RE: Response to Technical Evaluation Comments and Information Request #4 for Underground Injection Control (UIC) Permit Application Class VI

Pre-Construction Permit Application No. R9UIC-CA6-FY20-1

Figure 14: BB Co. 1 wellbore after P&A operation

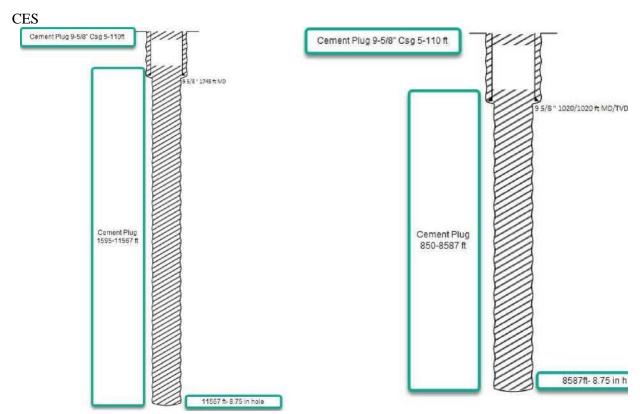
- The plugging procedures for Amstar 1 and BB Co 1 on pages 25 and 26 reference a casing diameter of 9 5/8 inches; however, figures 14 and 15 show that the hole is 8.75 inches. Please clarify the discrepancy.

- Comment noted. Attachments and plans will be corrected accordingly.
- Figure 46 of the permit application narrative shows the centroids of the water well locations. Please provide verified actual locations of the water wells.
- Please refer to Error! Reference source not found. in Appendix A of this document for surface locations of GW1 to GW4 shallow monitoring wells. These are the proposed monitoring well locations that will be drilled.

Figure 4-1. Mendota site location map with  $CO_2$  and pressure AoR (combination of maps from Figure 12 Attachment B and Figure 1 Attachment C of the original submission).

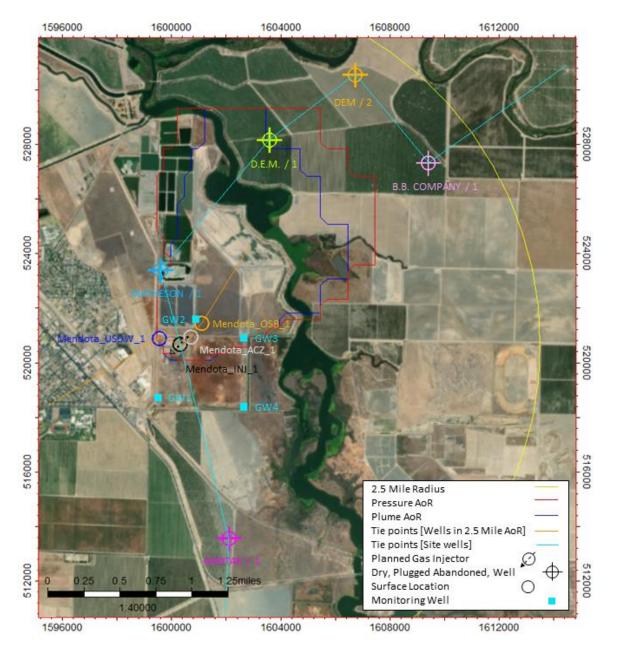
- Please provide a map that shows the location of the monitoring wells at a scale that also shows the extent of the plume and pressure front (i.e., Figure 12 of Attachment B and Figure 1 of Attachment C at the same scale)

- Please refer to Figure 4-1 in Appendix A in this document, which is the replacement map combining maps from Figure 12 Attachment B and Figure 1 Attachment C.

Figure 5-1. Mendota INJ 1 well schematic, including gauges and USDW. Updated figure.

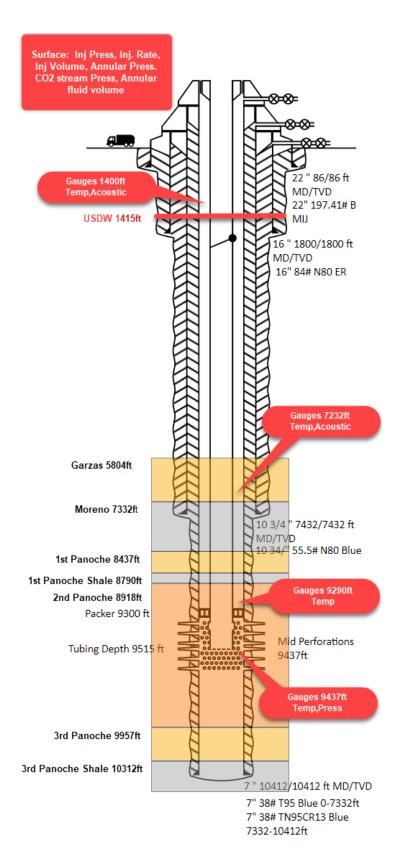
- Please describe more explicitly the location/depth of the pressure/temperature gauges at the packer.
- Please refer to Figure 5-1 in Appendix B for a well schematic that includes gauge placement and type.

- Comment noted. CES does not anticipate entering zones of significant water or hydrocarbon saturation at the planned well plug sites. Figure 5-1 of Appendix B illustrates the Moreno and Panoche formations as well as the primary injection zone relative to the well plugging schematic.

Figure 5-2. Plug and abandonment schematic, Mendota INJ 1, updated to reflect formation top sand cement plug configurations. Updated figure.

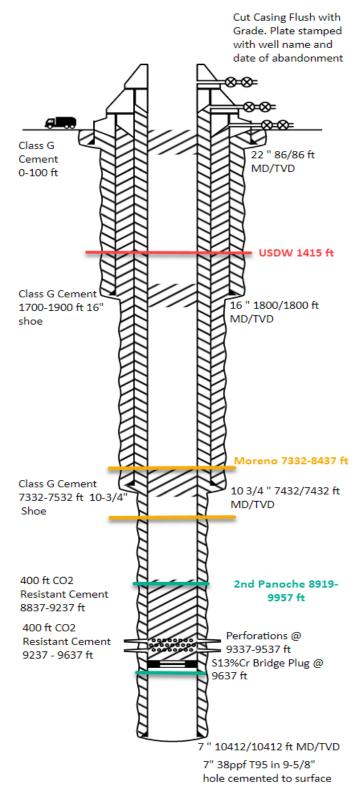
According to Figure 6.4, the perforations are 9,337 - 9,537 ft and the bridge plug is proposed to be set at
